## Addendum No. 3

**Project:** USC Hamilton College Renovation  
**Project No.:** U-651-07  
**State Permanent Improvement Project No.:** H27-9905-SG  
**Date of Issue:** May 8, 2014

Drawing No.  
**M1.1**

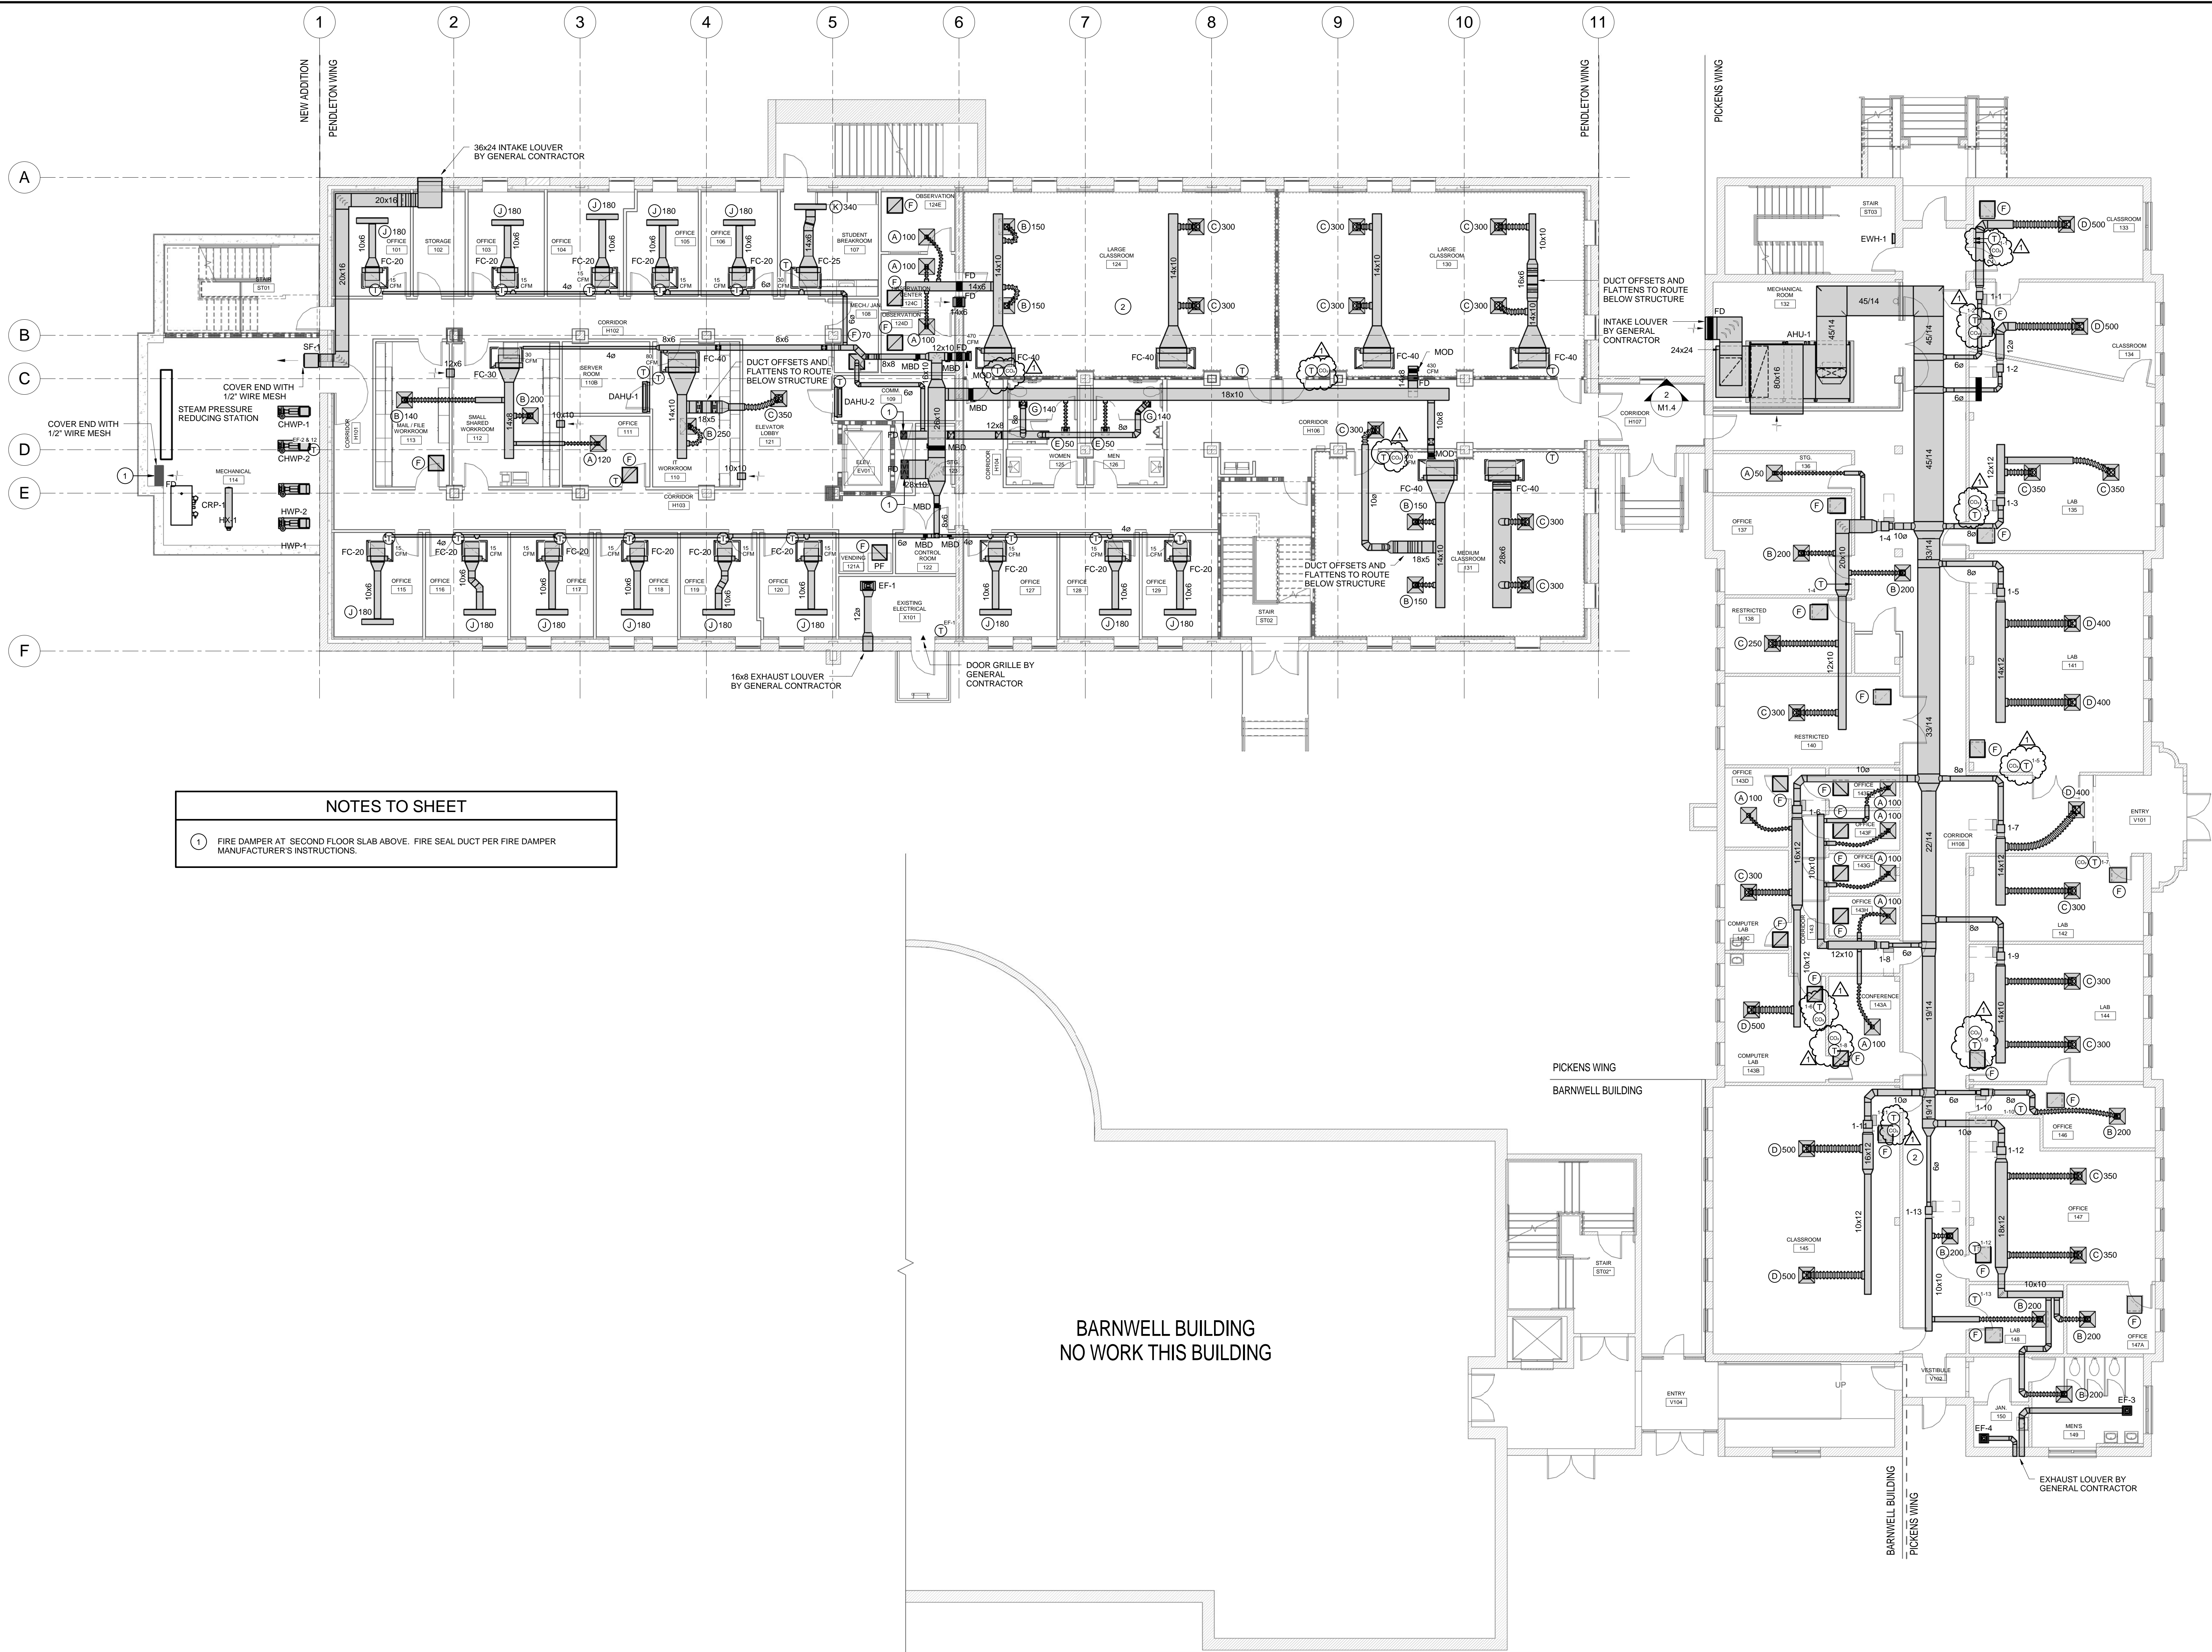
1. Sheet MS1.1, Mechanical Site Plan – See revised drawing MS1.1. This revised drawing revises the routing path for the chilled water, steam and condensate pipes.
2. Sheet M1.1, First Floor Plan – See revised drawing M1.1. This revised drawing shows the carbon dioxide sensor locations.
3. Sheet M1.2, Second Floor Plan – See revised drawing M1.2. This revised drawing shows the carbon dioxide sensor locations.
4. Sheet M1.2, Second Floor Plan – See revised drawing M1.2. This revised drawing removes the fire dampers at the Atrium where the fire rated wall is removed.
5. Sheet M1.3, Third Floor Plan – See revised drawing M1.3. This revised drawing shows the carbon dioxide sensor locations.

## M1.3

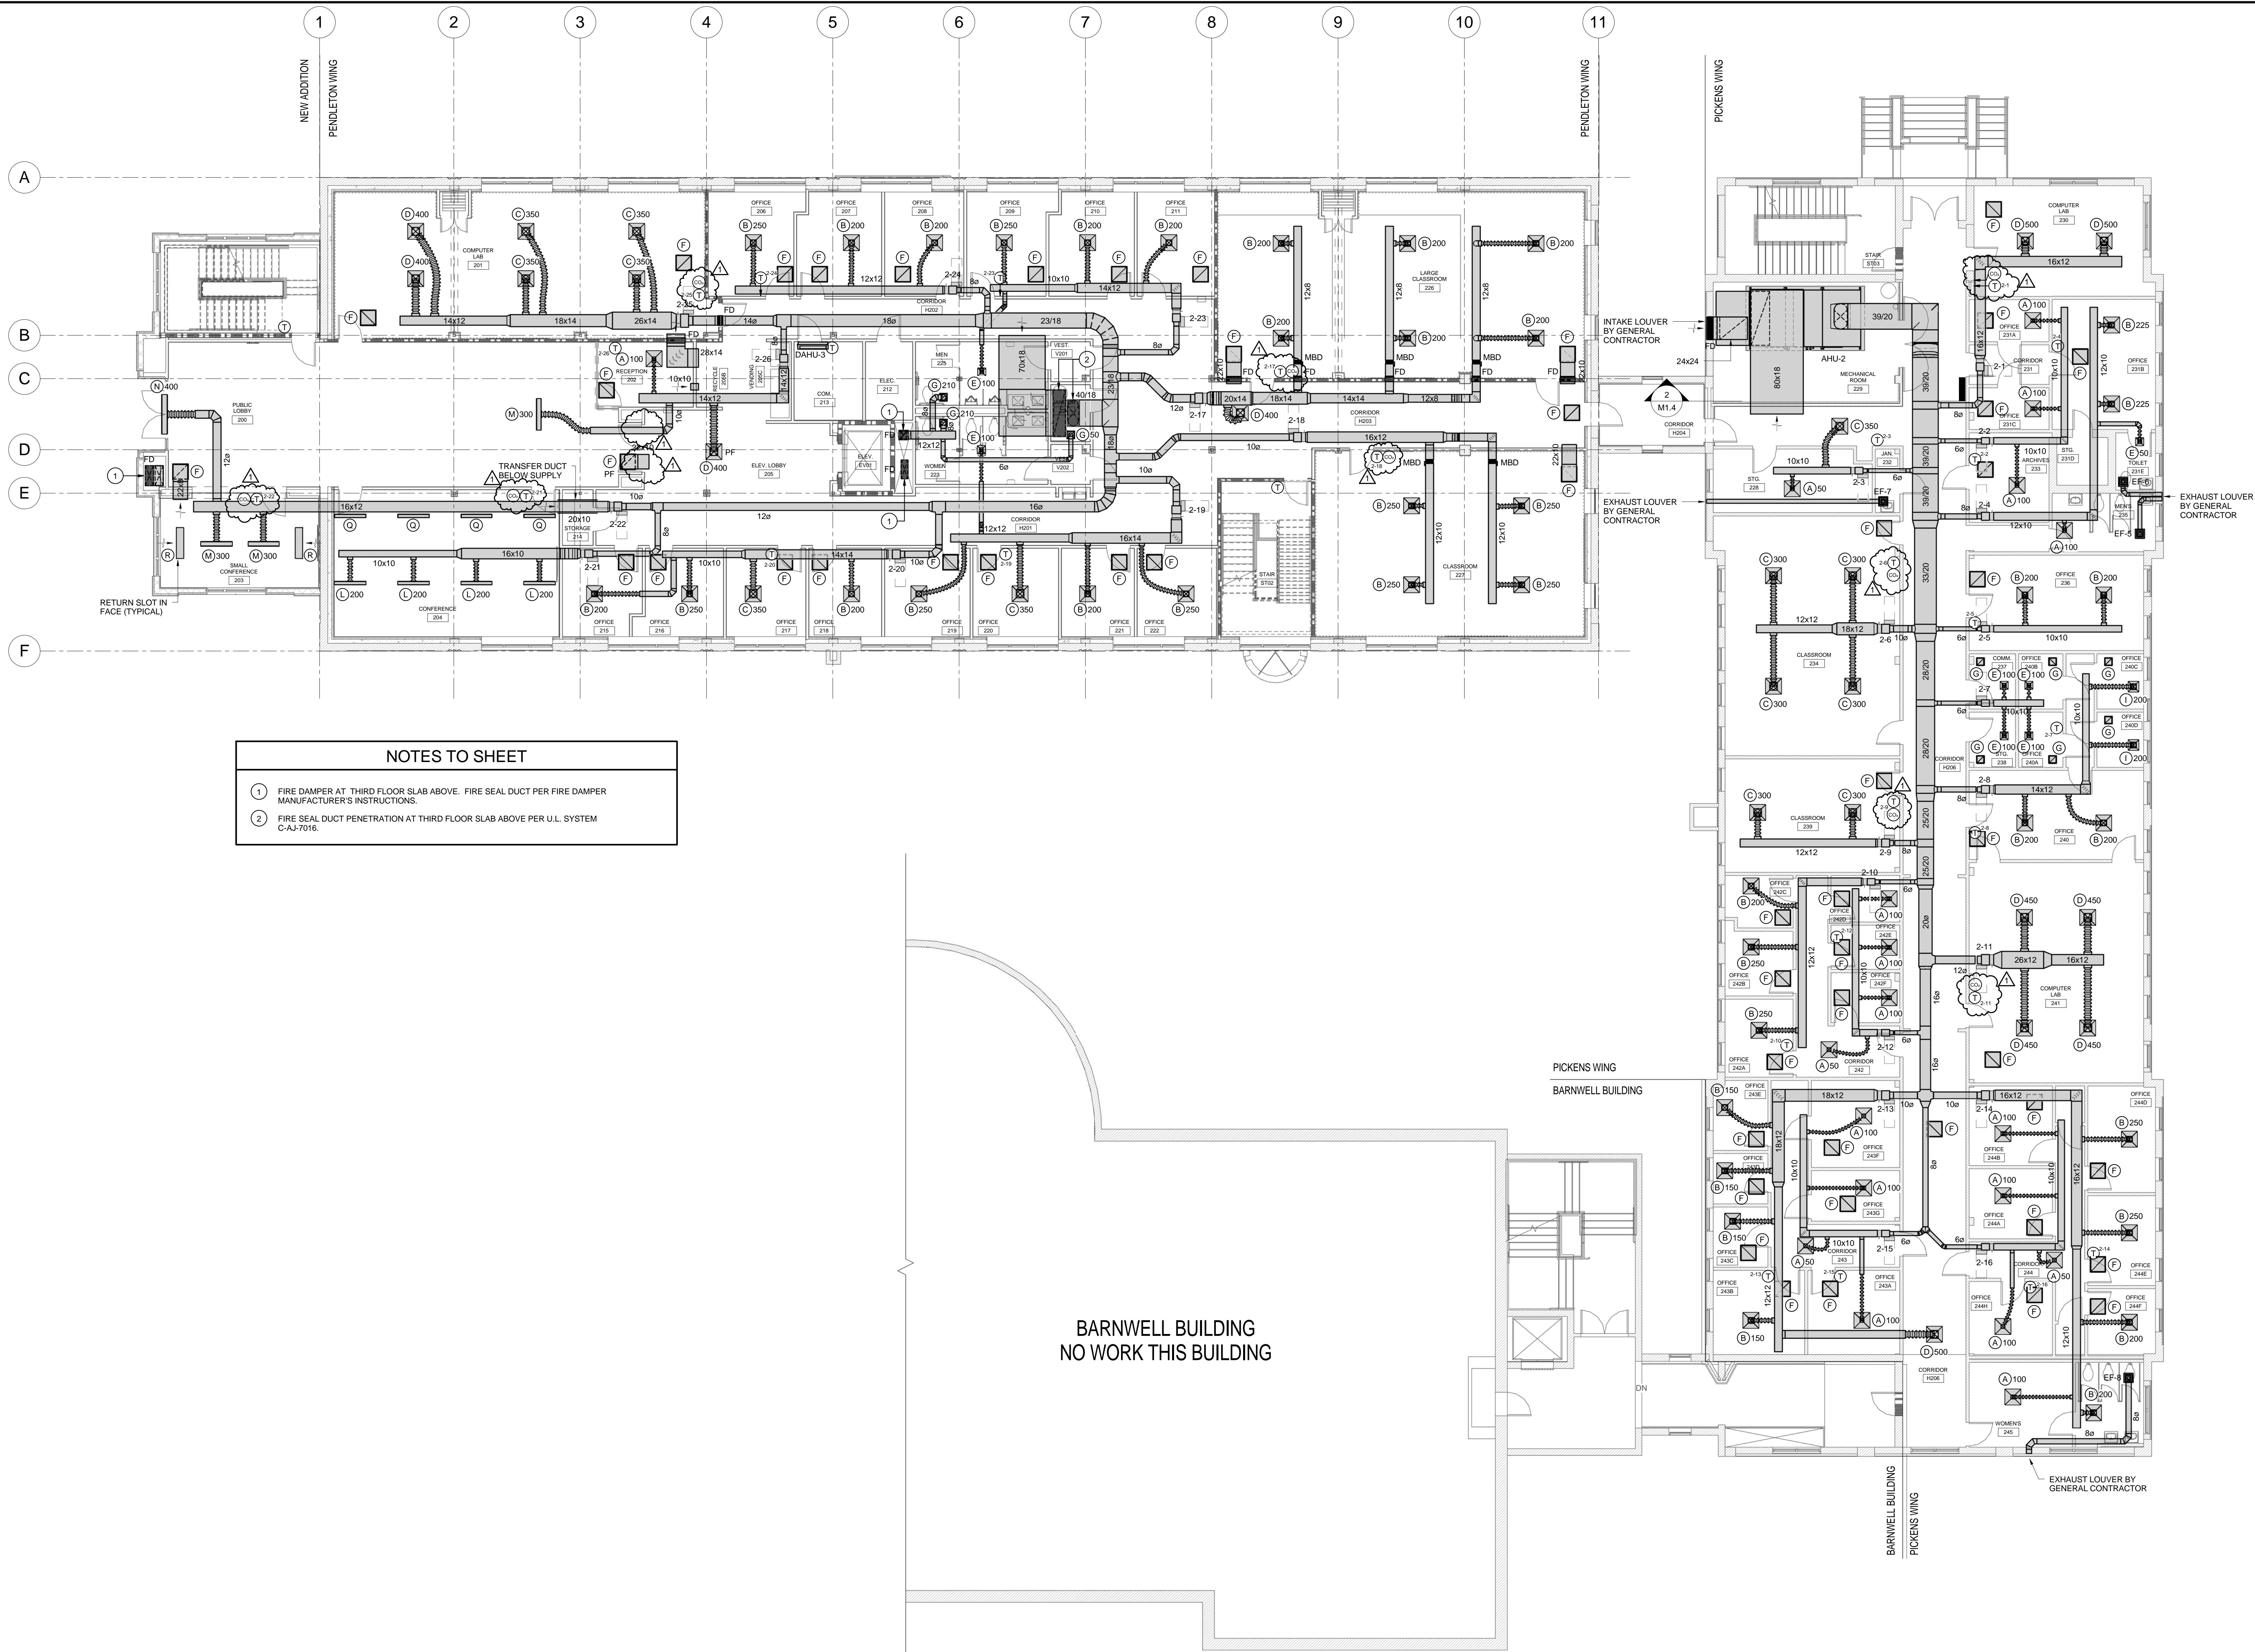
6. Sheet M1.3, Third Floor Plan – See revised drawing M1.3. This revised drawing removes the fire dampers at the Atrium where the fire rated wall is removed.
7. Sheet M2.3, Third Floor Plan - Piping – See revised drawing M2.3. This revised drawing removes the fire sealed pipe penetrations at the Atrium where the fire rated wall is removed.
8. Sheet M3.1, Piping Diagrams – Steam vent from pressure reducing stations shall be 6". Vent pipe shall be routed with in piping chase with hot and chilled water up to roof.
9. Sheet M4.2, Schedules, Legend and Details – Refer to the Legend, add symbol PF to refer to a Plaster Frame.
10. Sheet M4.3, Details – Revised drawing M4.3 adds Fan Coil Piping Diagram and VAV Heating Coil Piping Diagram.
